# UNITED STATES PATENT AND TRADEMARK OFFICE

| APPLICATION NO. | FILING DATE | FIRST NAMED INVENTOR | ATTORNEY DOCKET NO. | CONFIRMATION NO. |
|-----------------|-------------|----------------------|---------------------|------------------|
| 10/047,865      | 01/15/2002  | Reuel S. Orocio      |                     | 5116             |

**Office Action Summary**

## **DETAILED ACTION**

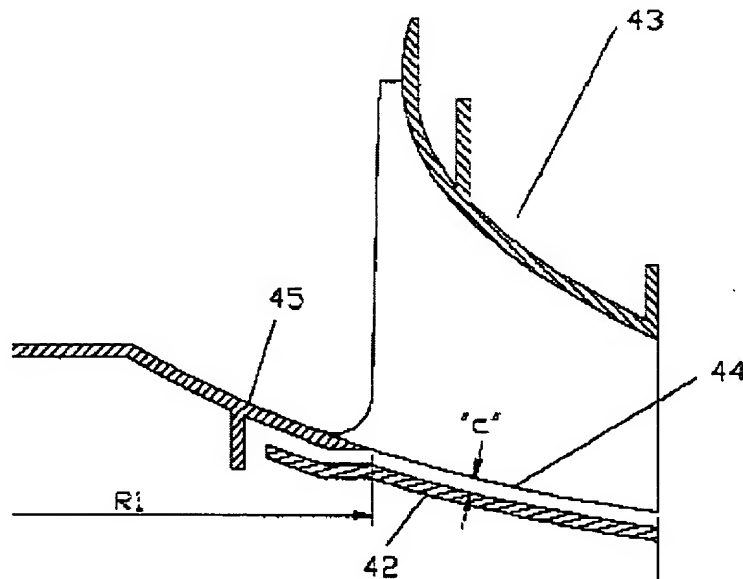
Chapman discloses in Fig. 4 (see below), a back plate (i.e. a cover) 42 located opposite the shroud relative to the vanes substantially enclosing the vanes. Chapman, however, does not teach the cover mounted on the hub covering the vanes, rather, Chapman quite expressly teaches the cover is not mounted on the hub and is formed with a stationary member such as the casing (see paragraph 0011).

Therefore, in the examiner's opinion, it would not have been obvious at the time the invention was made to a person having ordinary skill in the art to modify the stationary cover of Chapman and mount it to the rotating impeller hub, especially since Chapman teaches a simplified one-piece impeller made by an injection molding procedure rather than a multiple-piece impeller joined by welding or some other joining process.
